**REMARKS**

AMENDMENT UNDER 37 C.F.R. § 1.111  
U.S. Appln. No. 10/699,865

**AMENDMENTS TO THE DRAWINGS**

**FIG. 6**  
PRIOR ART

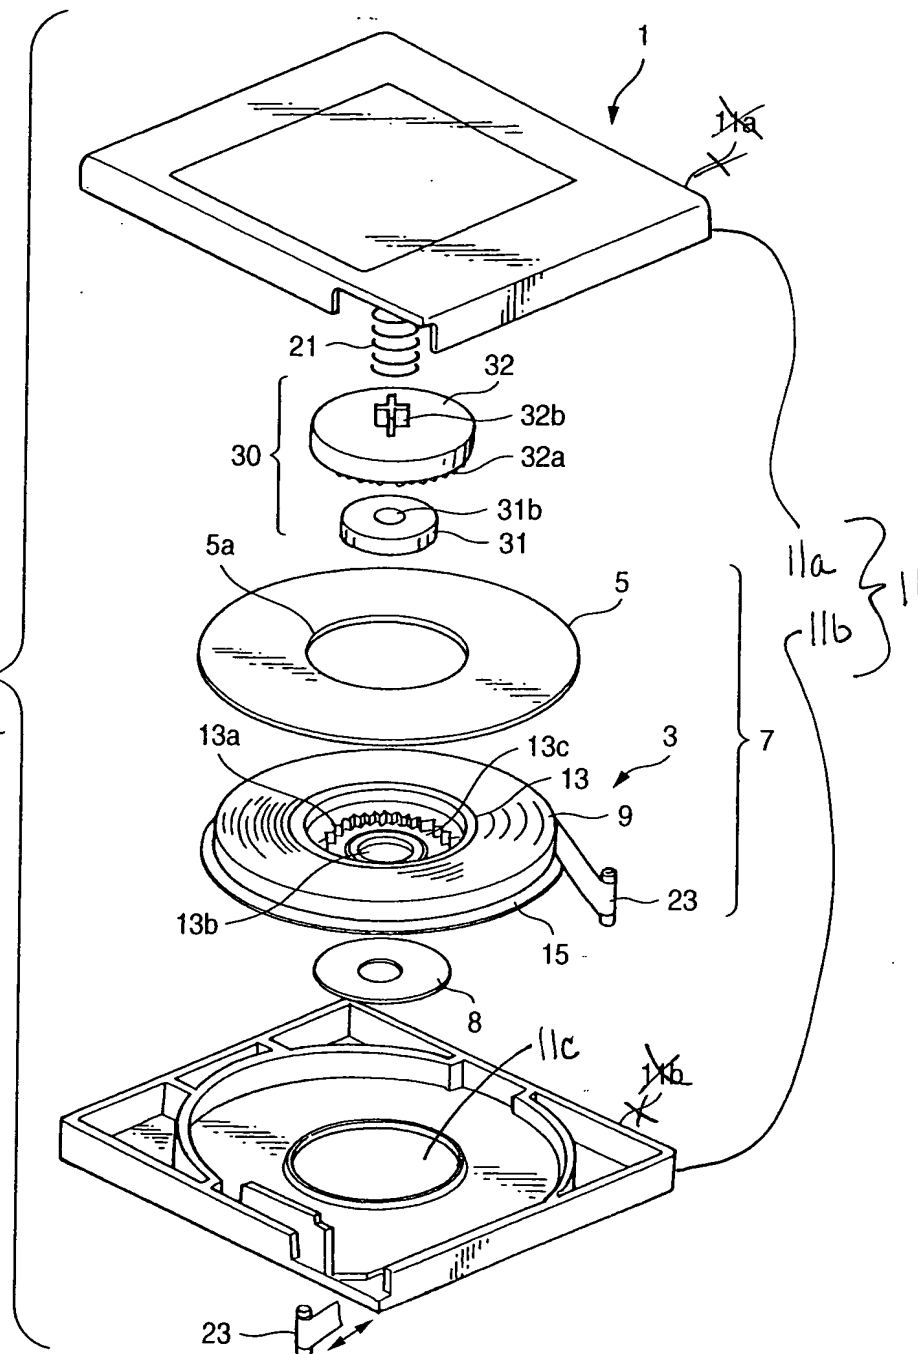
The Examiner has objected to FIGS. 6-8b because they are not labeled --Prior Art--. Applicant amends the drawings to overcome this objection.

In addition, “11” and “11c”, of the “Description of the Related Art” are added to Fig. 6 accordingly.

Applicant has amended FIGS. 6, 7, 8a and 8b to include the legend --Prior Art--. Also, FIG. 6 has been amended to add reference numerals "11" and "11c". Finally, reference numeral "31" in FIG. 7 has been amended to --15a-- in both instances. The submitted annotated marked-up drawings and replacement sheets are believed to obviate the Examiner's objection to the drawings.

FIG. 7 PRIOR ART

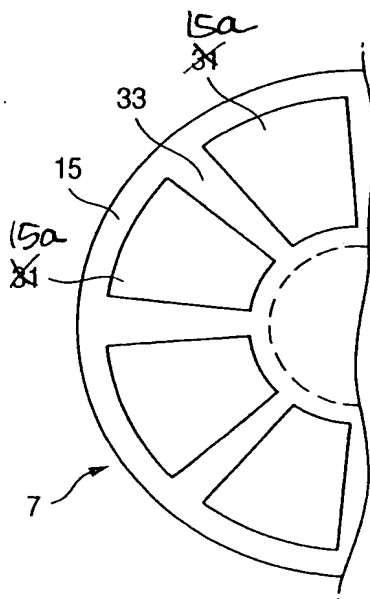
The specification is objected to because it appears that “31” is used for two different elements, the first member and the plurality of grooves. Applicant amends the specification and Fig. 7 to refer to the plurality of grooves as “15a”. Also “aperture” on page 9, line 24 is misspelled. Also, FIGS. 8a and 8b are now described separately in the Brief Description of the Drawings.

The Examiner considers the grooves of the prior art flange in Fig. 7 to render the flange “porous”. Applicant respectfully disagrees with this assertion. In particular, porous is understood by those of ordinary skill in the art to mean “having or full of pores” and pores are understood by those of ordinary skill in the art to be “tiny openings”. See *The American Heritage Desk Dictionary*, Houghton Mifflin Company, 1981. Common synonyms for porous include “absorbent” and “permeable”.

The prior art flange of Fig. 7 is not porous; rather this flange has very large portions missing altogether, so that the center of the flange is connected to the perimeter of the flange by spindle-like portions. This is completely different than a porous surface.
